Harbour North - North Viewpoint - Percent Alteration

Harbour North - North Viewpoint - Percent Alteration and Conclusions

Harbour North - North Viewpoint

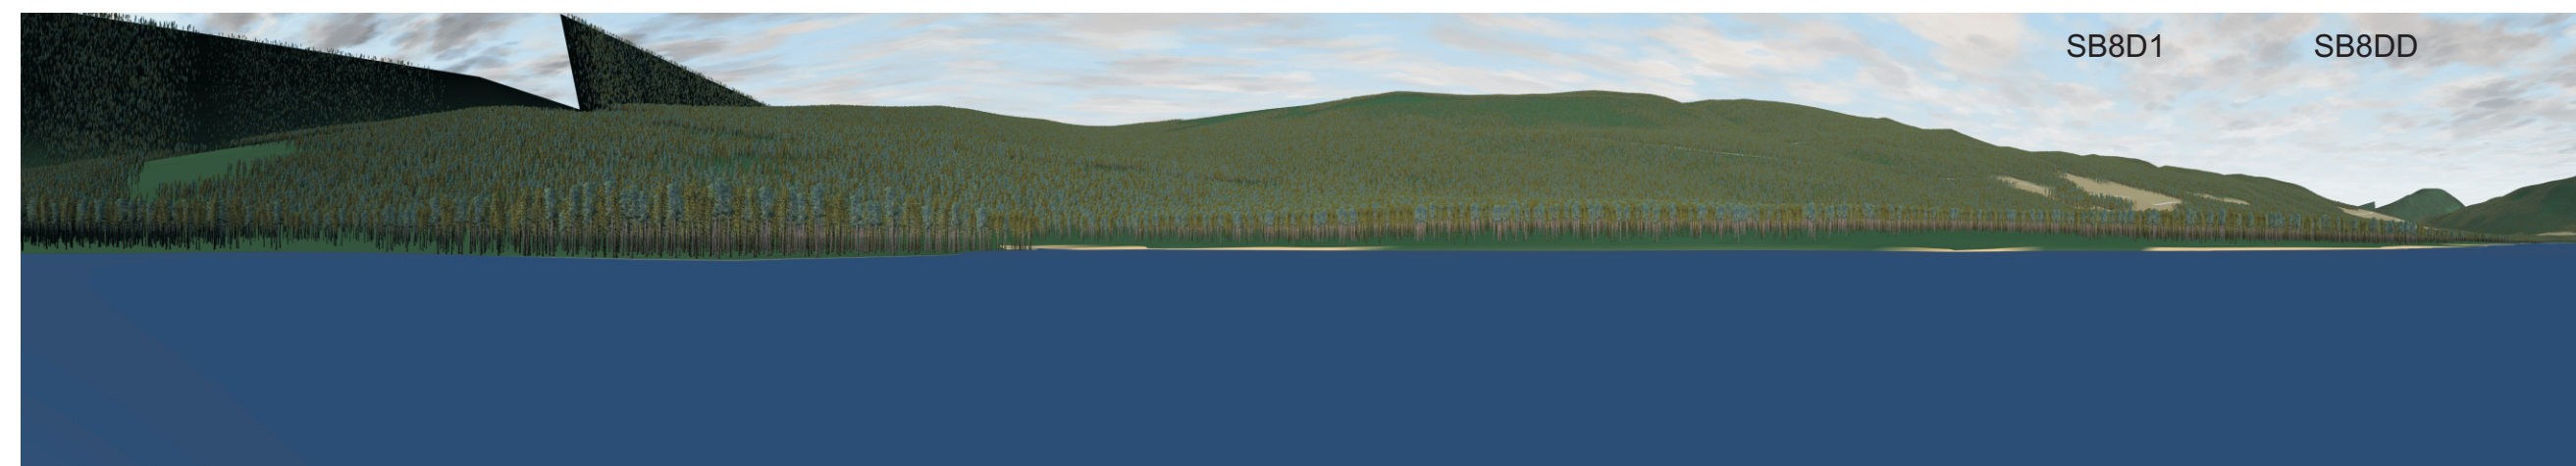
Percent Alteration within the Landform above the Park exceeds VQO upper limit by 2%. When Park/shoreline is included, Percent Alteration drops to 5.4%. However, the Park does not contribute to the Timber Harvest Landbase and is properly excluded. The shoreline, which is the main portion of the park on the west side of the lakes, is also typically excluded.

Design is now favourable with recommended RDI leave areas, but Percent Alteration should be reduced by a minimum additional 2%. The units in perspective and their percent contribution are shown in the table. The greatest reduction(s) would be achieved by deferral of one or more of the largest openings as seen in perspective view, such as SB8D1-D, or SB8DD-A, and/or a grouping of smaller openings. RDI will identify these precise areas on the planimetric map.

Total planimetric area of currently suggested RD leave areas to achieve 9.12% alteration is 10ha. Additional planimetric area reduction will be calculated following discussion and further guidance.
